AGENDA
PLANNING AND ZONING COMMISSION MEETING
CITY OF CREVE COEUR, MISSOURI
MONDAY, NOVEMBER 3, 2014
7:00 PM

**APPLICATION TO PLANNING AND ZONING COMMISSION
#14-033 FOR APPROVAL OF THE MINOR SITE PLAN FOR NEW
AWNINGS AT THE APPLEBEE'S RESTAURANT AT
11950 OLIVE BOULEVARD**

FOR THE MEETING OF: Monday, November 3, 2014 (continued from
October 20, 2014)

**APPLICATION TO PLANNING AND ZONING COMMISSION
#14-036 FOR APPROVAL OF A BOUNDARY ADJUSTMENT BETWEEN
MISSOURI BAPTIST UNIVERSITY AND TEMPLE CORPORATION CHURCH
OF JESUS CHRIST OF LATTER DAY SAINTS**

(6) SIX ALUMINUM AWNINGS • CREVE COEUR, MO

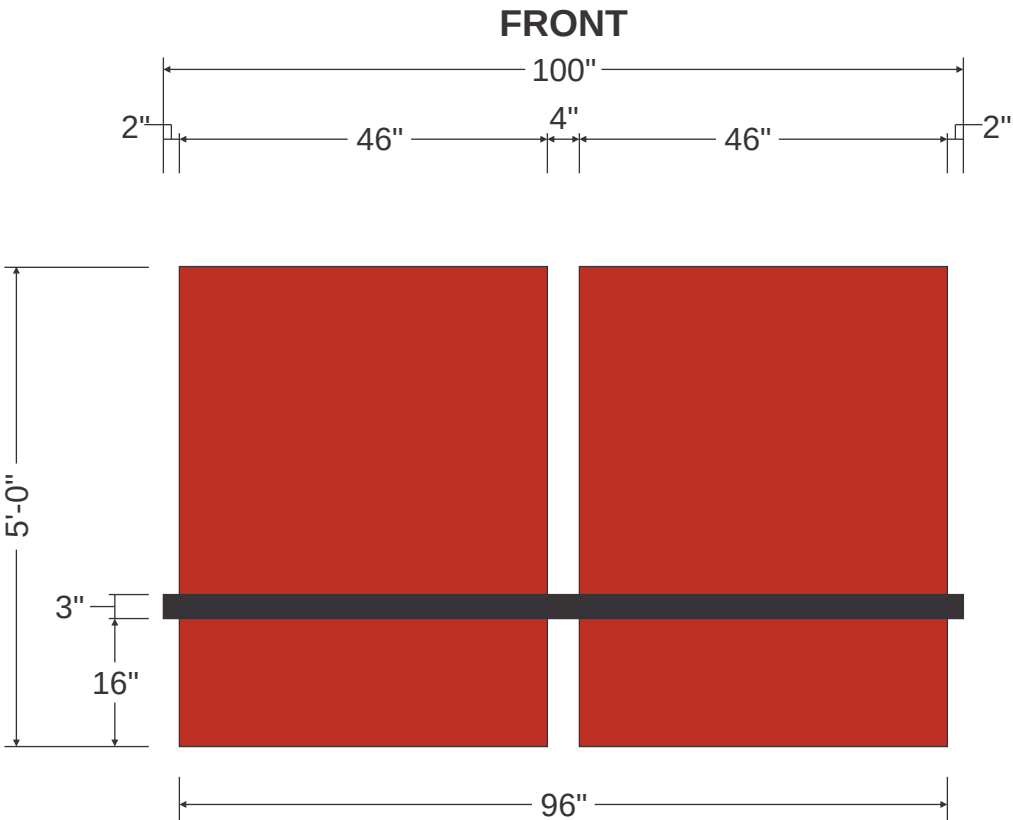
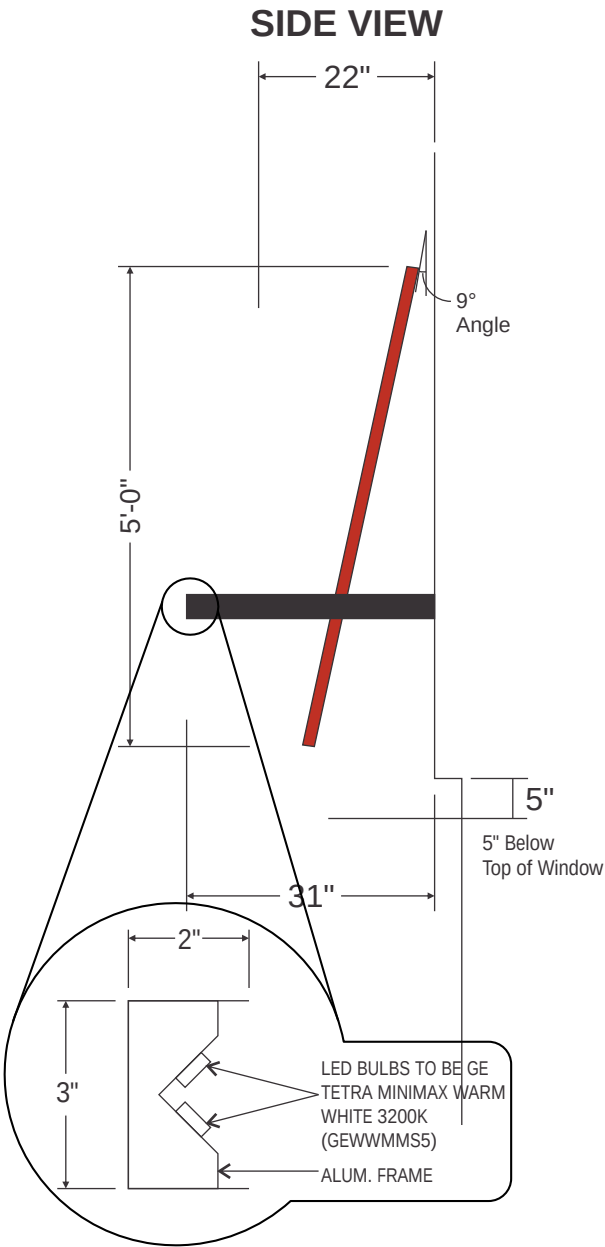
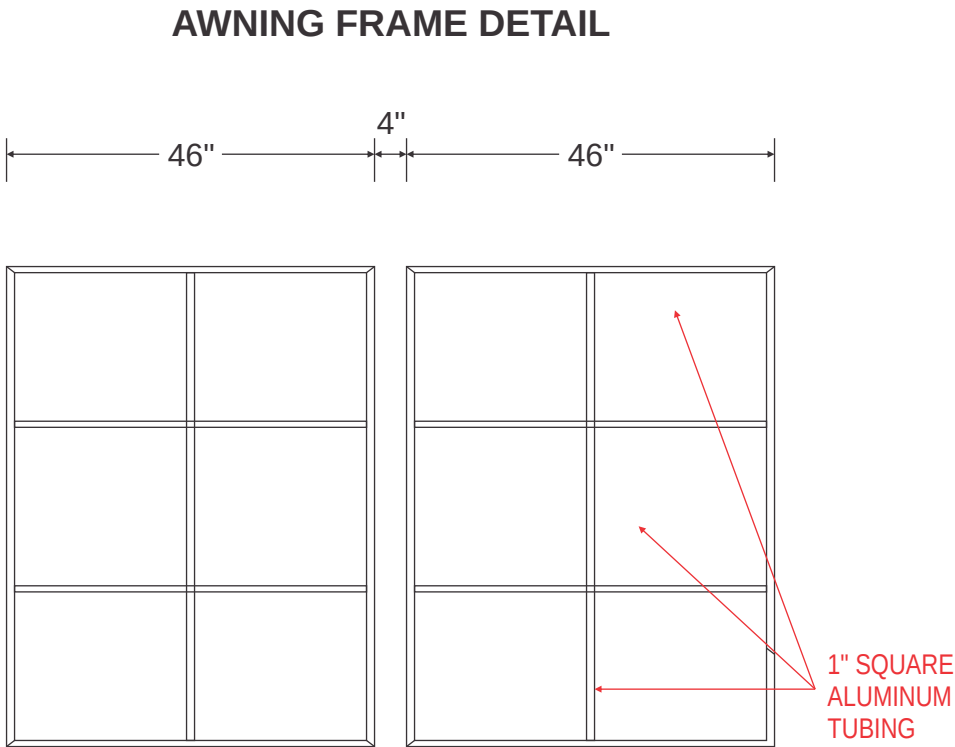
The Applicant has submitted revised drawings for non-brand specific color awnings for the north and east elevations of the building based upon comments from the October 20th meeting in a scale more appropriate to the building. The Applicant has indicated that the original awnings were 48 inches in height and the new proposed awnings below are 60 inches in height. Due to variations of colors from printers and screens, it is unclear about the shade of red the awnings will be. Therefore a condition of approval includes that the red should match the red color at the center of the apple design. With the recommended conditions of approval, Staff finds that the new proposed awnings are consistent with the Design Guidelines.

The critical point is the incorporation of elements that create "human scale" storefronts. While awnings can provide human scale to the front of the building, the overall size and height of the proposed awnings are less so. They are intended to serve as an attention getting device for those traveling along Olive Boulevard, thus not in keeping with the Comprehensive Plan. The awning over the front door, provides for a human scale and protection from the elements when entering and exiting, however the "Welcome Back" sign will need to be removed or scaled down, as it exceeds the size requirements for an incidental sign of two square feet.

1. The awnings shall in substantial compliance with the drawings submitted on October 29, 2014, except that the red color shall match the center red color of the apple design of the sign already on the building.
2. The sign over the entrance shall be reduced to two square feet.
3. A building permit shall be obtained for any work on the exterior, including work that is already completed that did not receive a building permit prior to the installation of the awnings.

(4) FOUR APPLE SHADOW ALUMINUM AWNINGS • CREVE COEUR, MO

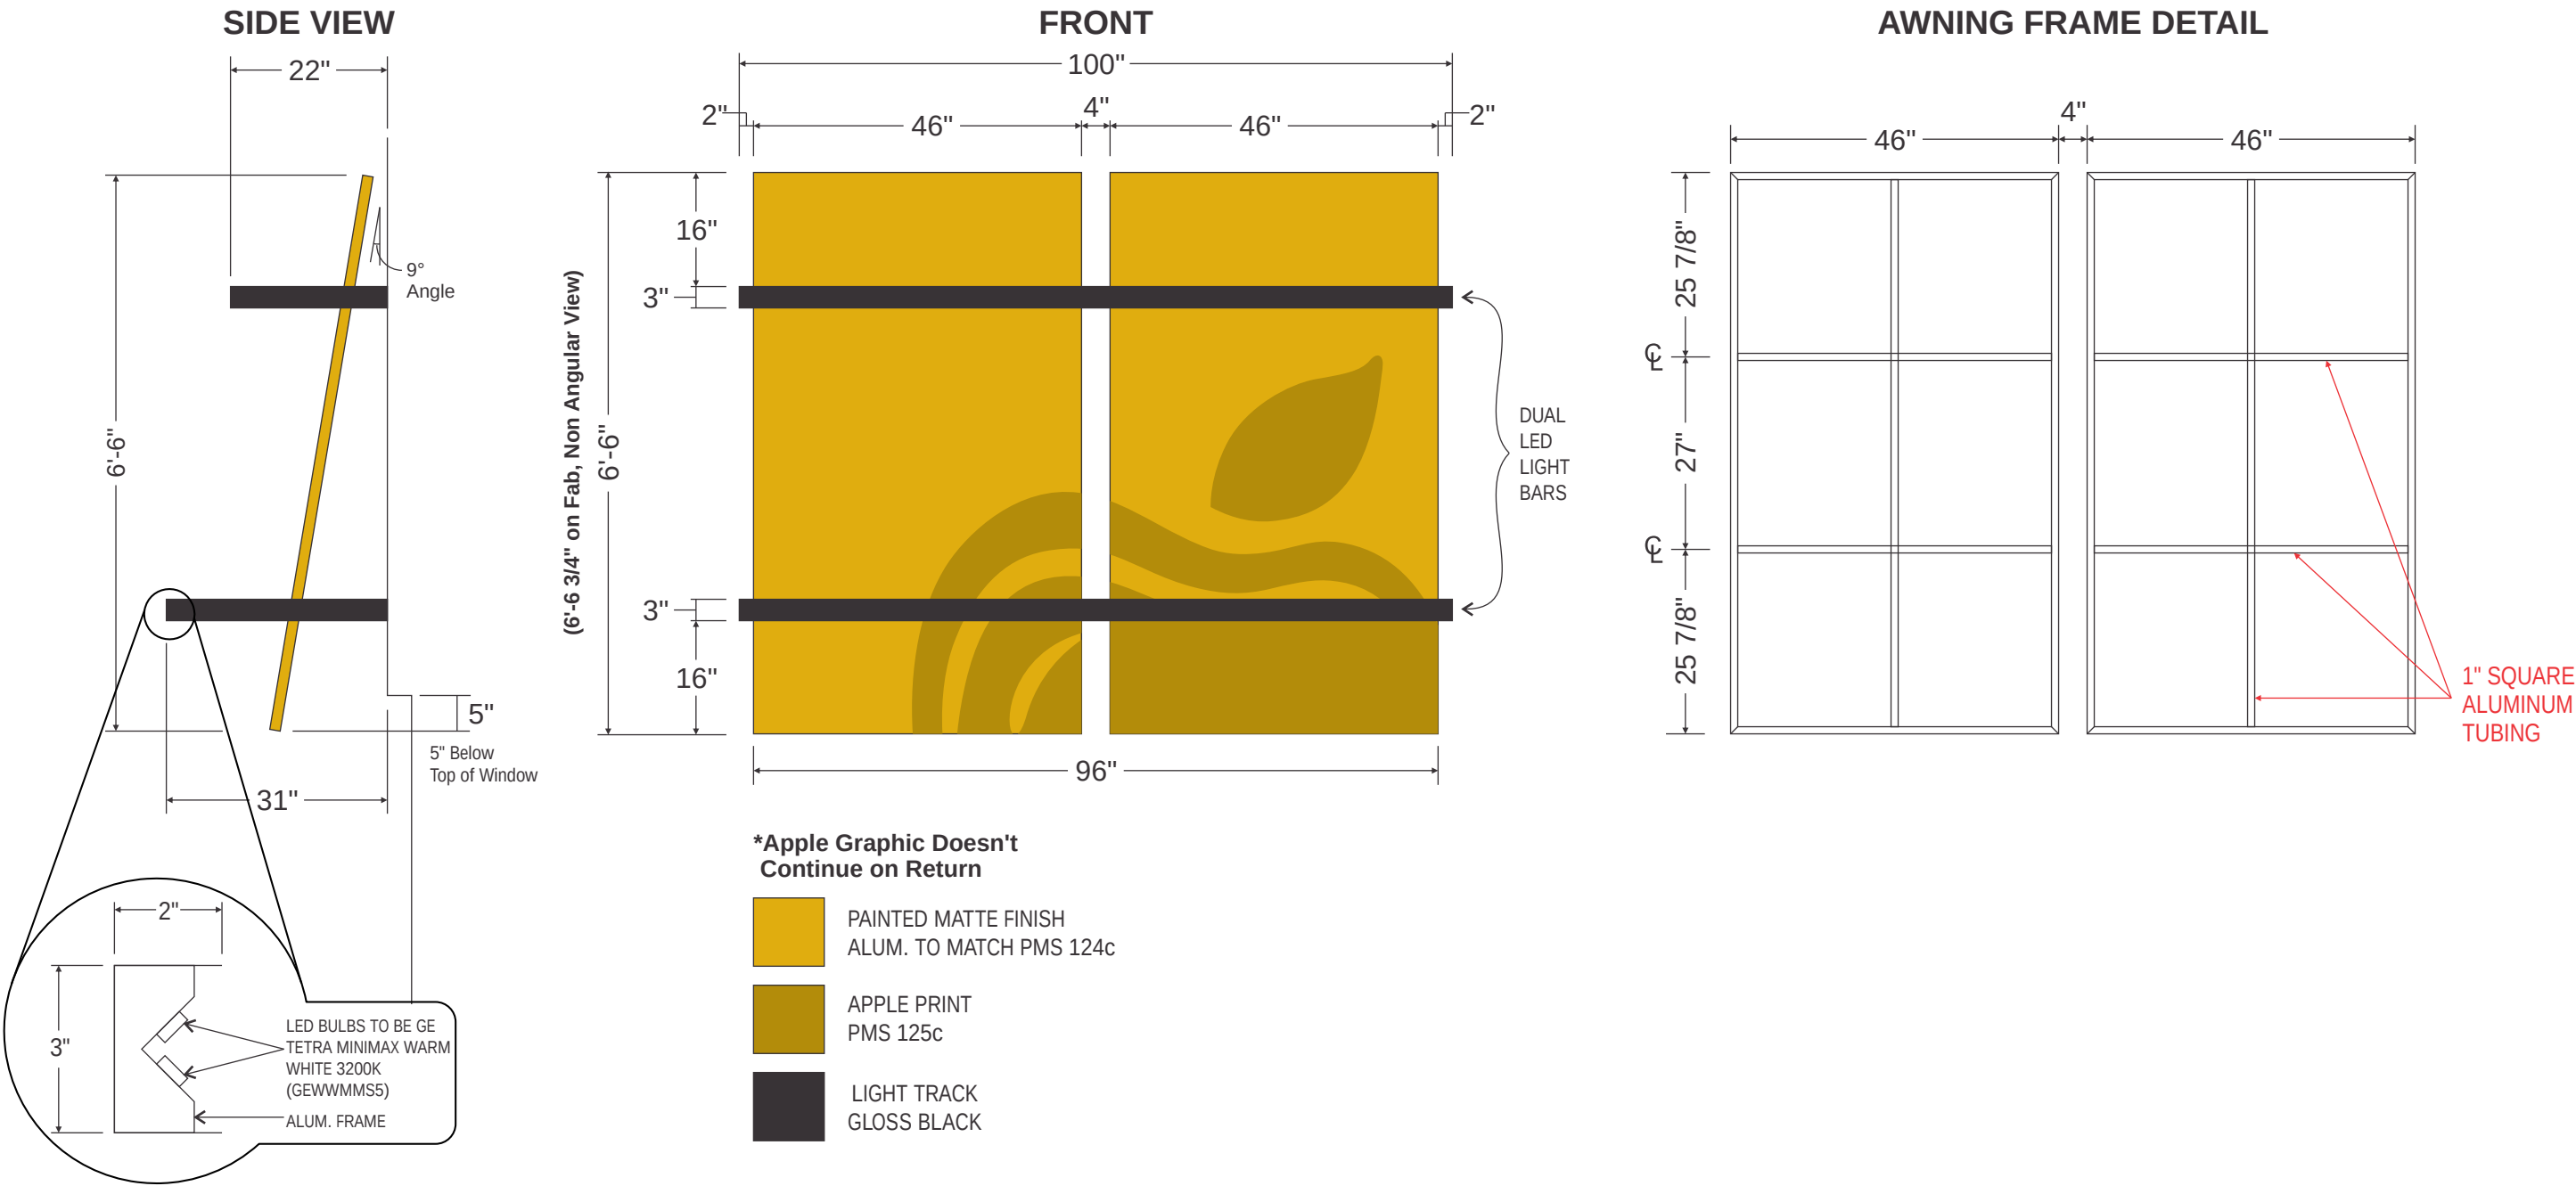
The Applicant has indicated that a red color within the new corporate color scheme may also be an option (without the apple graphic as shown in Figure 5). However, this would not be their preferred choice, due to the lack of contrast, and attention getting scheme with the building.

ATTACHMENTS: Boundary Adjustment Plat received October 17, 2014

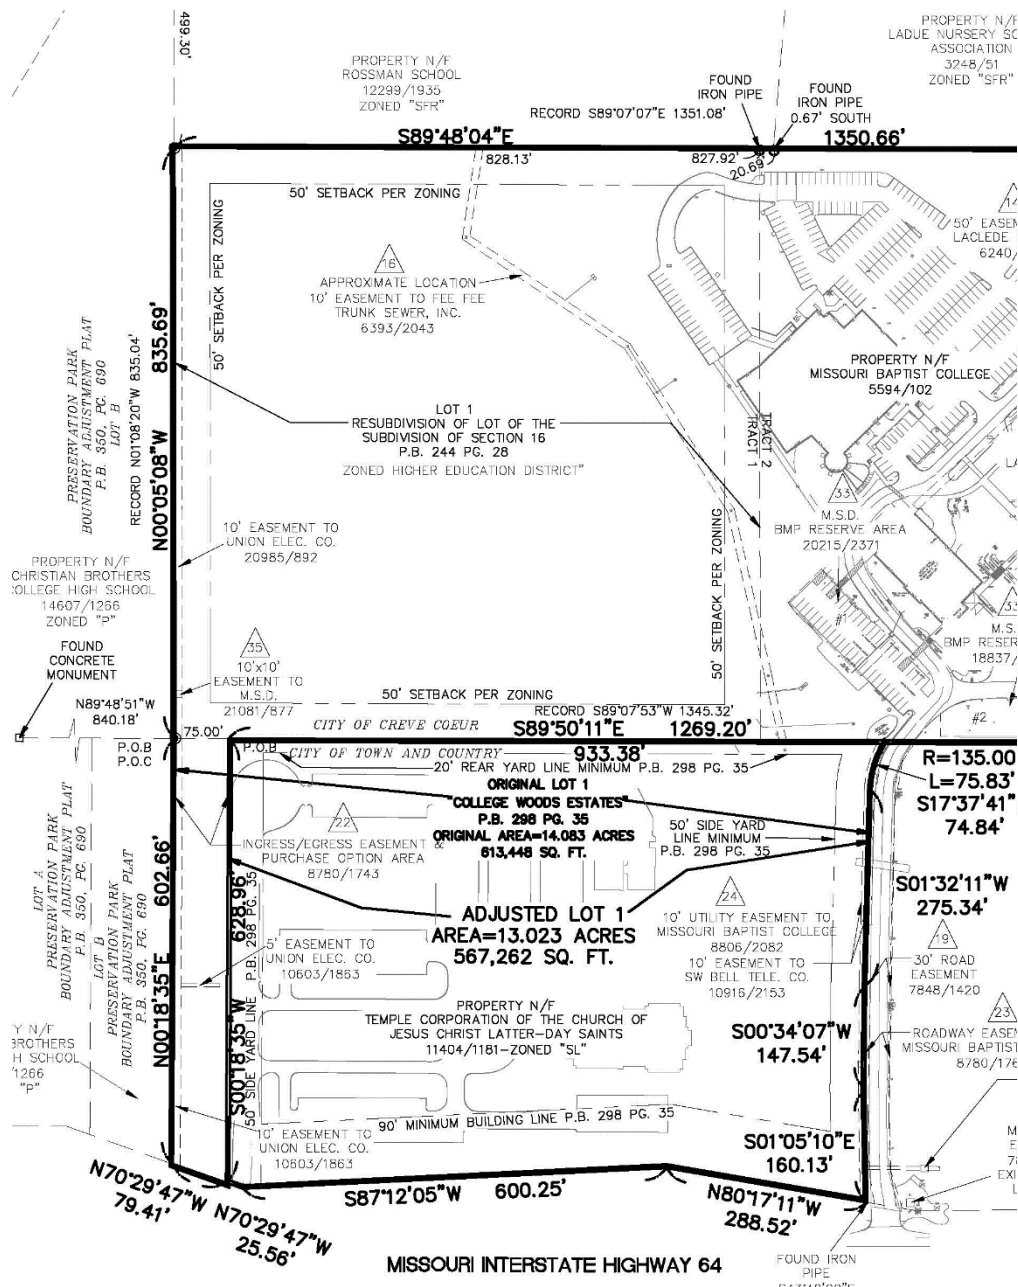
This appears to be the case with the current application. The survey submitted indicates that the property changes will not create non-conformities on the property. As such, and given the staff conclusion that the drawings are technically accurate, the adjustment should be approved by the Planning and Zoning Commission, with the condition that the final drawing be prepared with the corrected original lot area, for signature and recording.

“I move to approve the Missouri Baptist University and the Church Of Jesus Christ Of Latter Day Saints boundary adjustments attached to the staff report on Application #14-036 for the meeting of November 3, 2014, subject to the condition that a final drawing be prepared for signature and recording.” (Conditions may be added, eliminated, or modified by preceding motion)
